<u>AGENDA – FINAL</u> WAUKESHA COUNTY BOARD OF ADJUSTMENT

WAUKESHA COUNTY DEPARTMENT OF PARKS AND LAND USE APPEAL FOR VARIANCE STAFF REPORT

FILE NO.: BA184

Variance from **Section 3(h)2 Shore Setback** provisions of the Waukesha County Shoreland Protection Ordinance to reconstruct and reconfigure retaining walls on the subject property.

EXHIBIT A

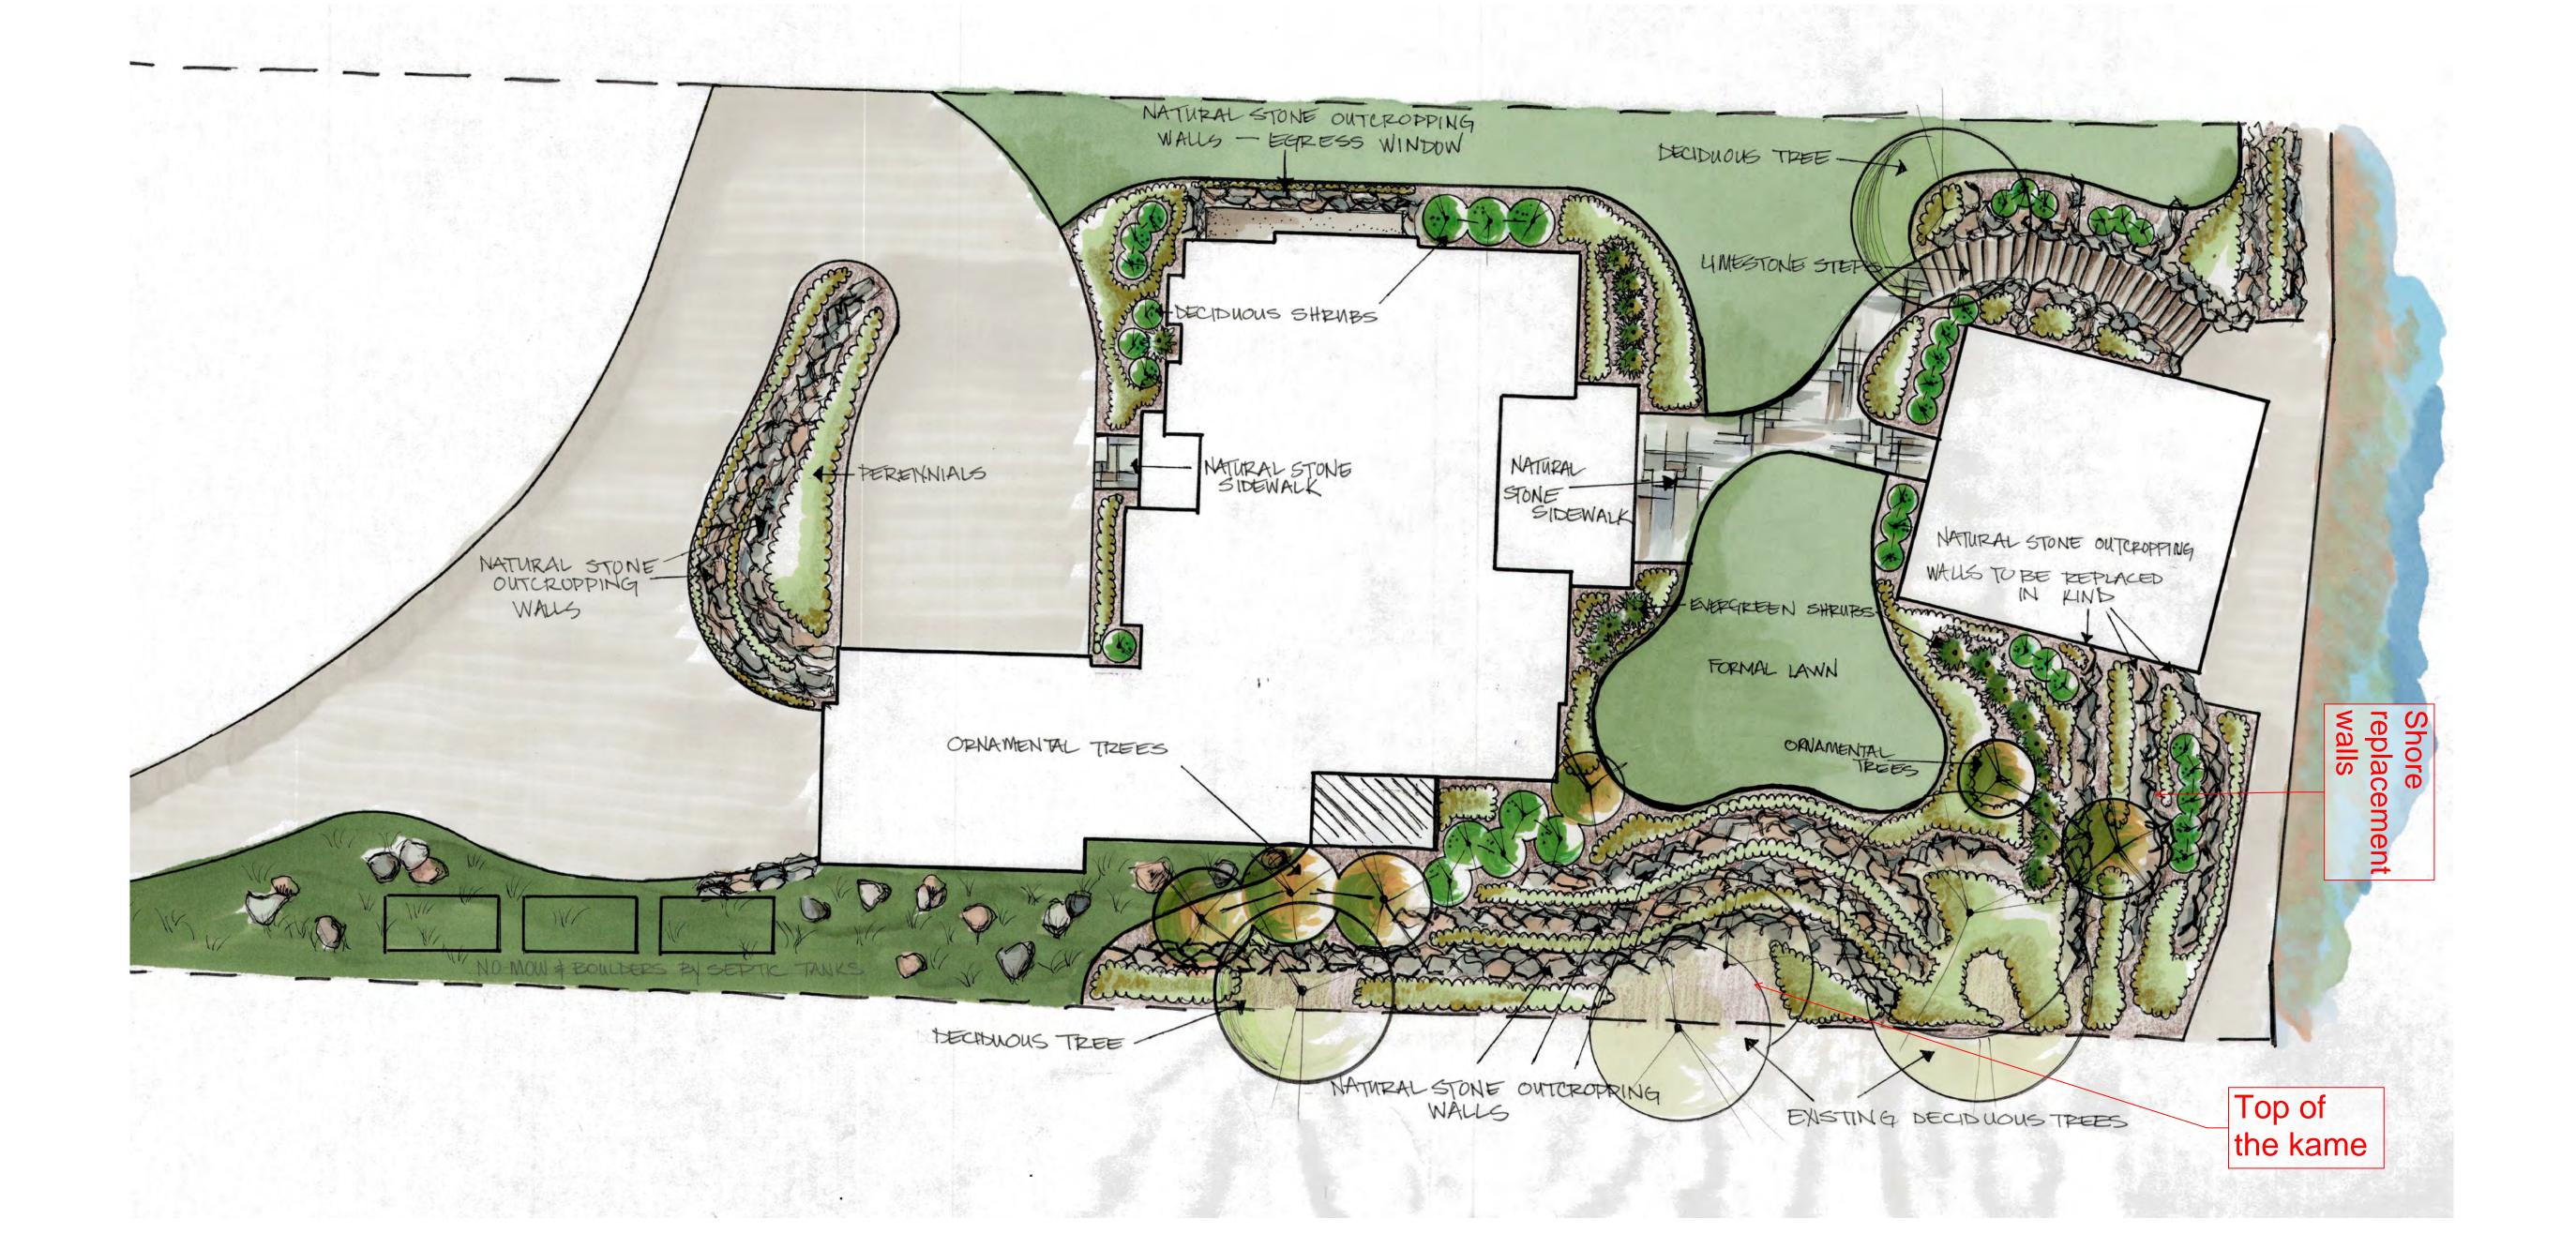
- 1. This approval allows for the replacement retaining walls to be substandard to the shore setback requirement, substantially consistent with the wall locations as shown on Exhibit A (concept landscape plan) and Exhibit C (proposed Plat of Survey). The final wall configuration proposed on the east side of the property (the kame), in concert with the proposed grading, shall be approved by the Waukesha County Park and Planning Commission via a Conditional Use for Land Altering Activities.

- 3. The replacement east-west retaining wall system near the shore shall be substantially consistent with the size and location of the existing retaining wall series near the shore, which is approximately 3 ft. from the shore as shown on the existing Plat of Survey (Exhibit B).

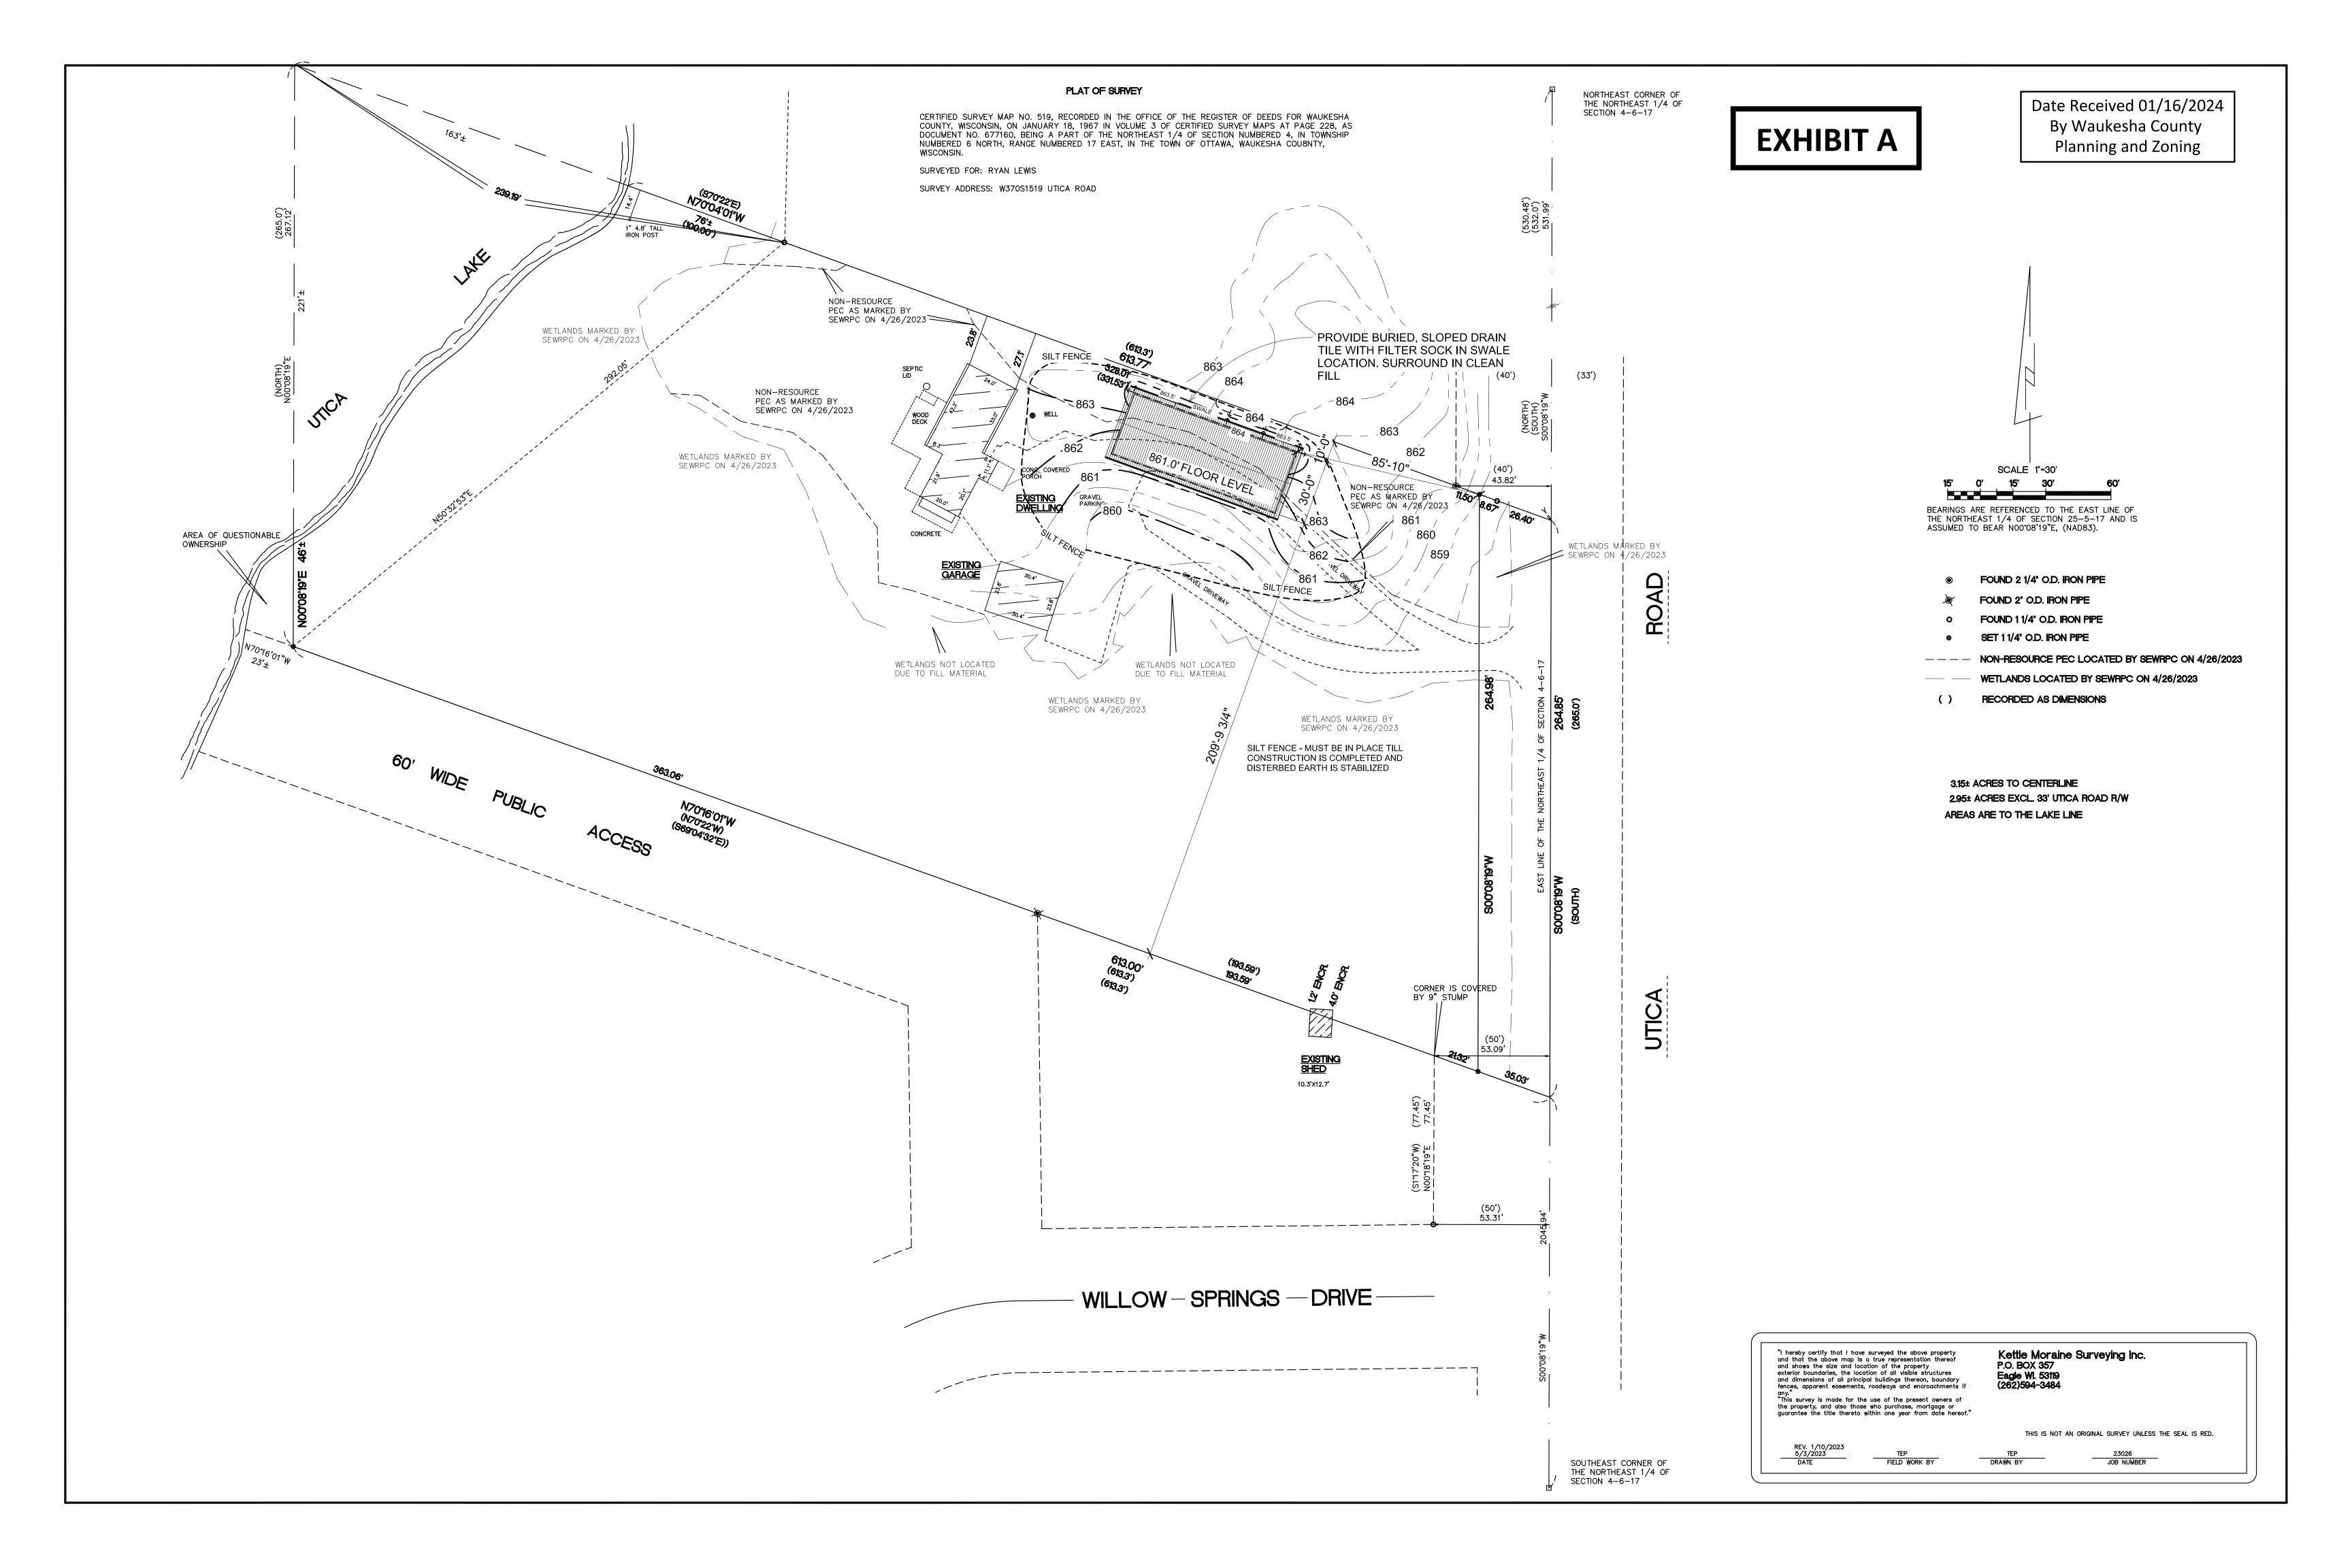
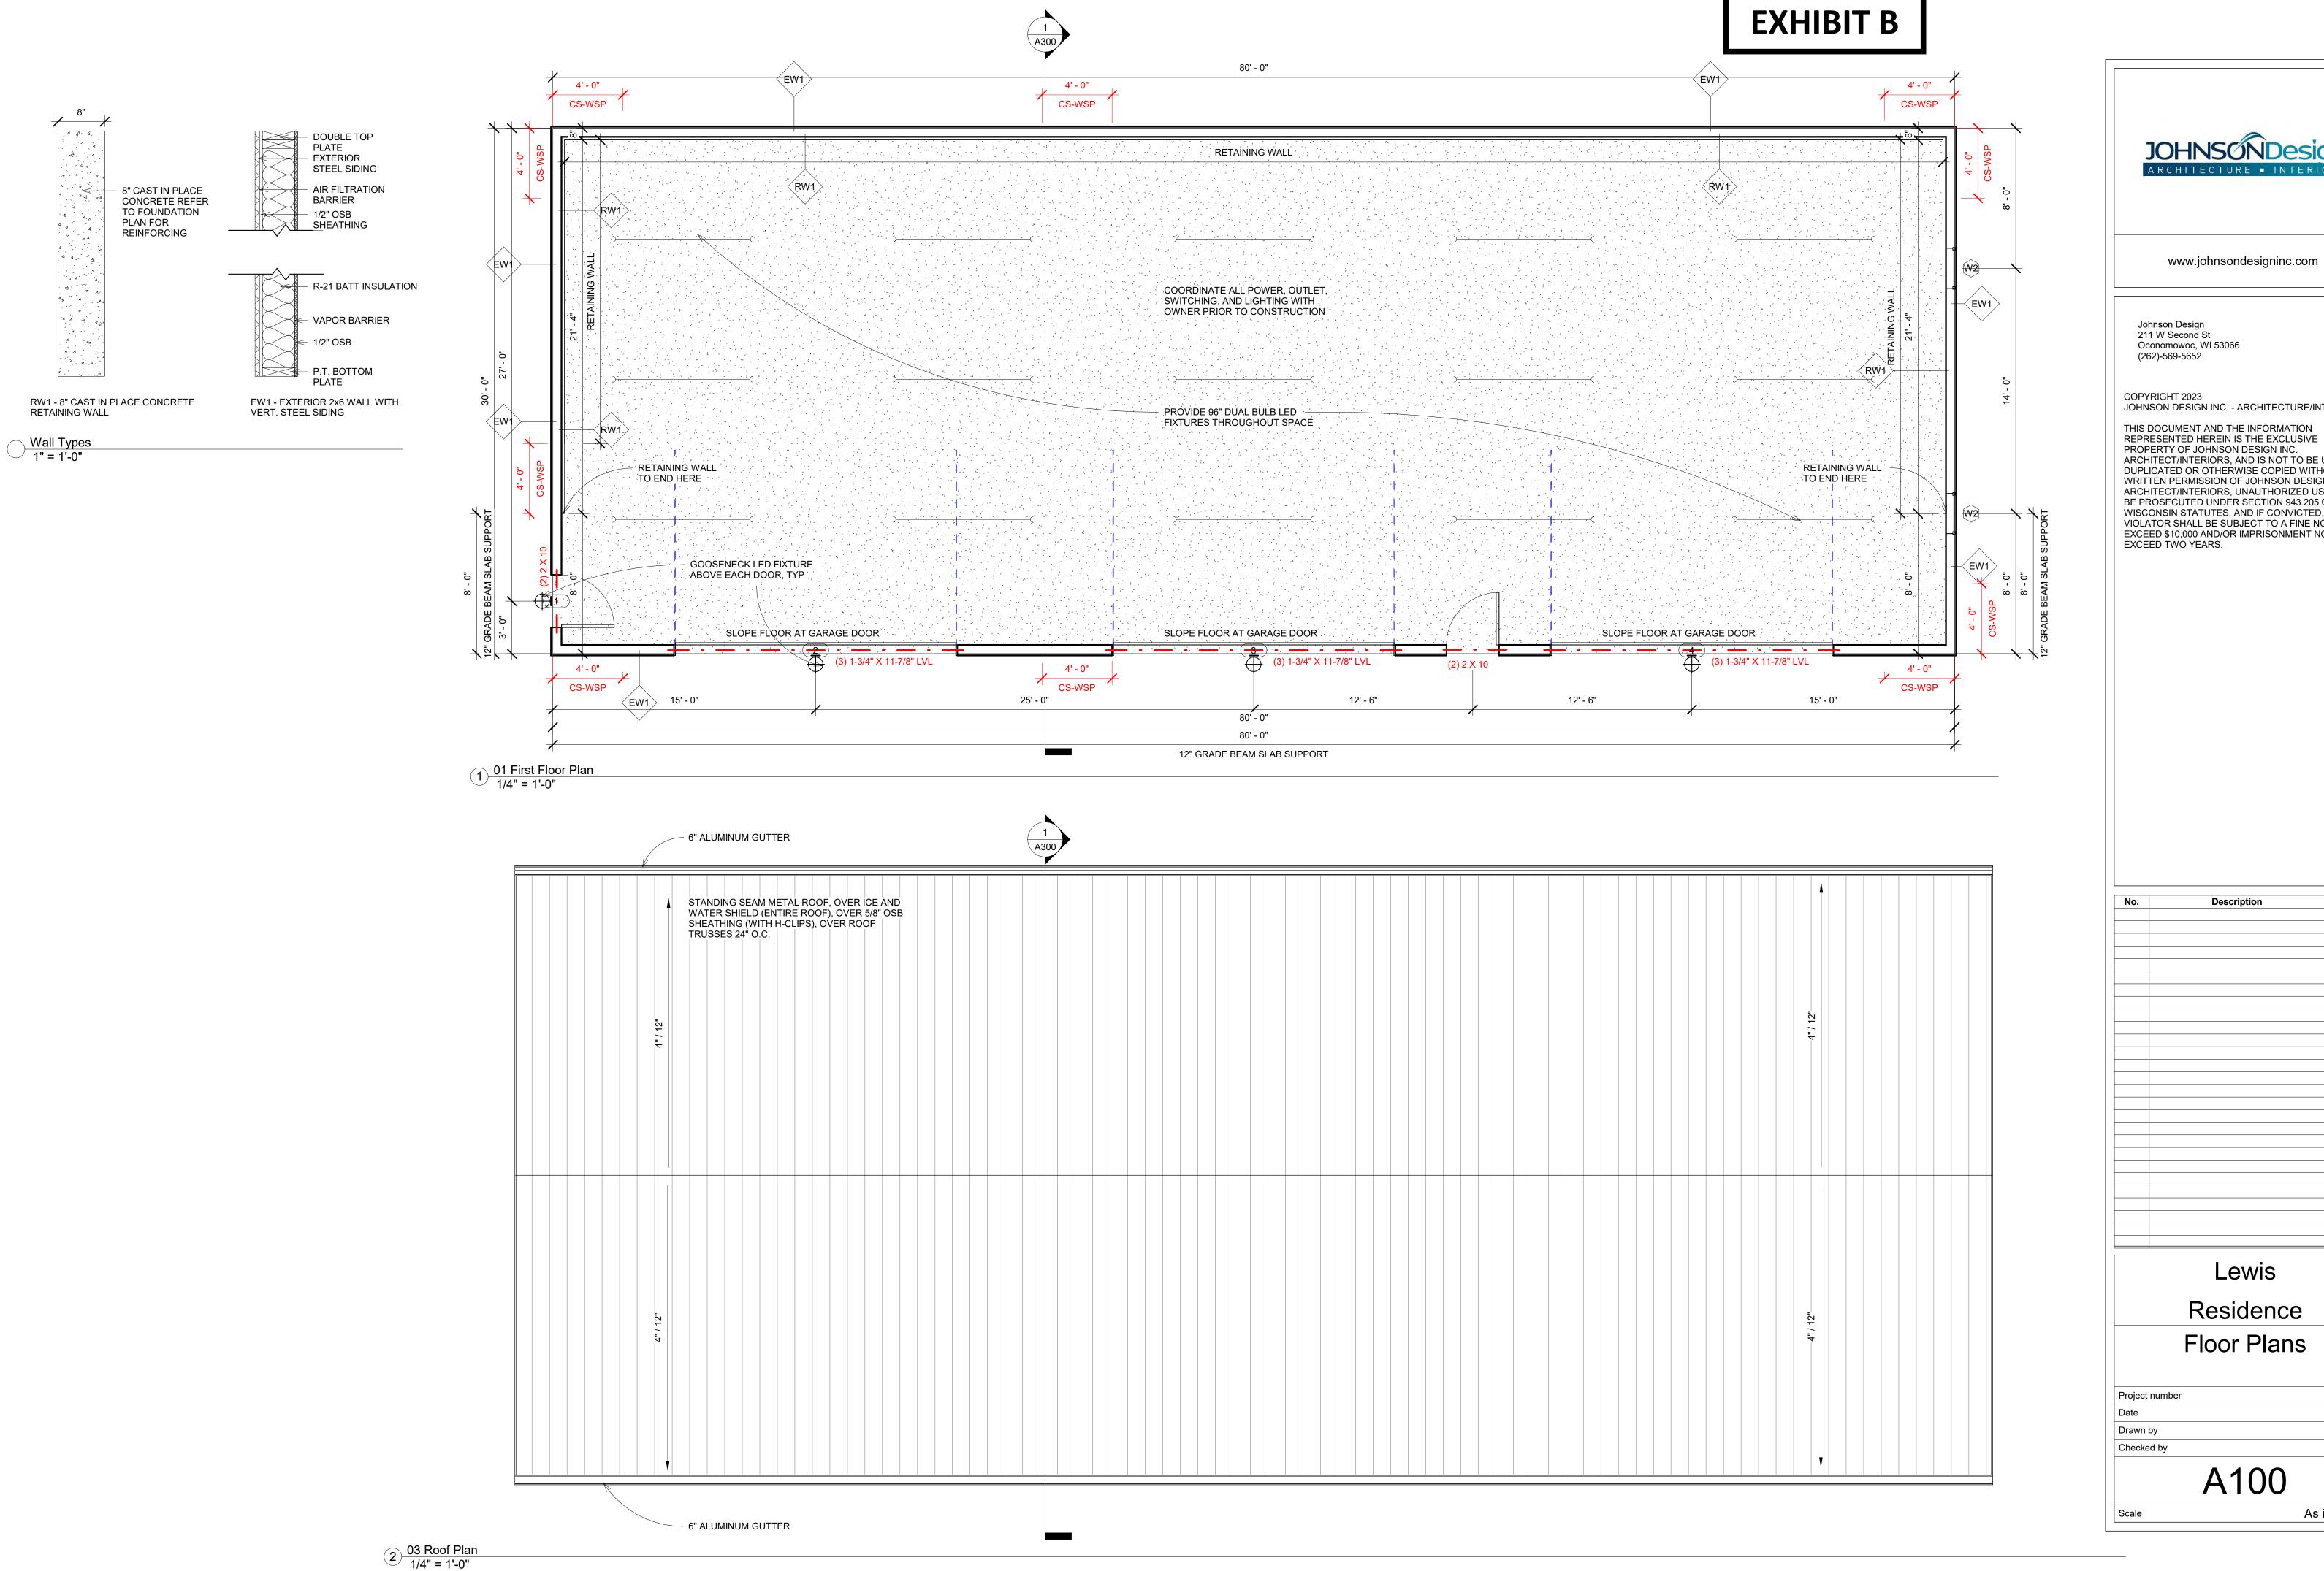
- 1. The accessory building is limited to a maximum of 600 sq. ft. with overhangs no greater than 2 ft. maximum width.
- 2. The accessory building and any associated site grading shall be located outside of the Primary Environmental Corridor. No trees shall be removed.

- 3. As proposed, the existing upper-level driveway shall be removed and restored with topsoil and grass prior to the occupancy of the accessory building or by October 1, 2024, whichever is sooner. The gravel removal shall be substantially compliant with the area shown on Exhibit D.

- 6. Prior to the issuance of a Zoning Permit, a revised Plat of Survey showing the staked-out location of the accessory building and the final impervious surfaces to remain on the property shall be prepared by a professional land surveyor and submitted to the Planning and Zoning Division staff for review and approval.
